METROPOLITAN GOVERNMENT OF NASHVILLE AND DAVIDSON COUNTY

STAFF RECOMMENDATION 918 Shelby Avenue November 20, 2013

Application: New construction-infill
District: Edgefield Historic Preservation Zoning Overlay
Council District: 06
Map and Parcel Number: 08216040600
Applicant: Matt Schutz, designer; John Donelson, owner
Project Lead: Robin Zeigler, robin.zeigler@nashville.gov

Description of Project: Applicant proposes to construct a two-story, two-part commercial building at the corner of South 10th Street and Shelby Avenue.

Front Elevation 1/8"=1'

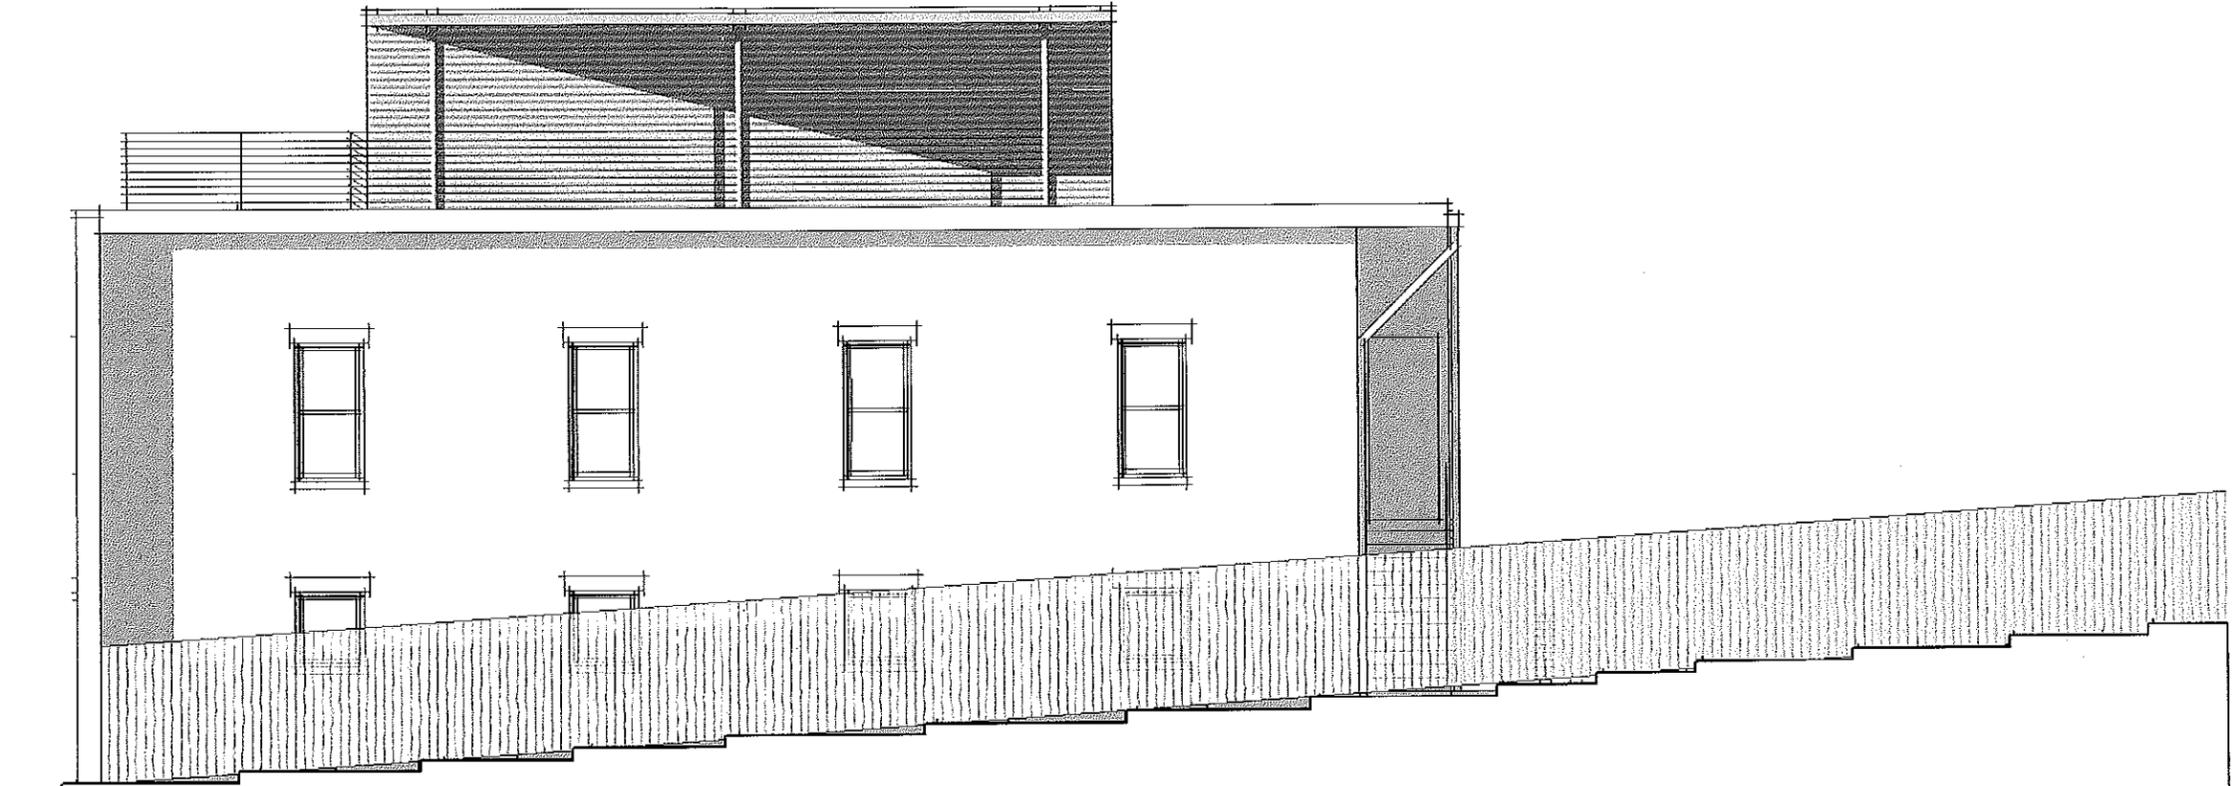
Height & Scale: The grade changes dramatically from the front corner to the opposite rear corner. At its highest point on Shelby Street, the building is proposed to be thirty-three and six inches (33' 6") tall from grade. The building includes a trellis roof that adds another nine feet (9') in height.

The zoning code provides a maximum height at setback of thirty feet (30'). The eclectic context, which includes small one-story homes as well as two and two and one-half story homes, also does not support thirty-four feet (34'). In 2006, a duplex was approved at 915 Shelby Street that is approximately thirty-feet tall and in 2005 a one-story home was approved at 814 Shelby Street that is approximately twenty feet (20') tall. Staff recommends that the overall height be lowered so that the building is no more than thirty feet (30') tall from the lowest point of existing grade, to better match the context and meet the bulk zoning requirements. Although the proposed will still be taller than the majority of buildings in the immediate area, its flat roof and location at a low grade, will minimize its height.

The steel columns of the porch are narrow compared to the massing of the building and appear to be out of scale. Typically porch posts, even on commercial buildings, have a

post and cap. Staff recommends a thicker post that includes some type of post and cap. With this condition, the project meets section II.B.1.and 2.

Materials: The corner building will be clad in stucco on the left side and the front corner with brick on the right side. The smaller building will be clad in brick on the front. Materials for the right side and rear were not indicated. Because materials typically changed horizontally, rather than vertically, staff recommends that the entire corner building be stucco or brick rather than stucco on two facades with brick on the third. In addition, staff recommends staff review façade materials for the right side and rear elevations.

- More detailed drawings be submitted prior to issuance of a permit;
- The overall height (not including the rooftop pergola) be lowered to thirty-feet (30') as measured from existing grade at the front setback;
- The front porch posts be thicker to be more appropriate to the overall scale of the building and include a cap and base;
- Applicant obtains staff approval of the details and materials for windows, doors, brick and pavers;
- The corner building be all stucco or all brick; and
- The HVAC be located on the rear façade, or on the roof.
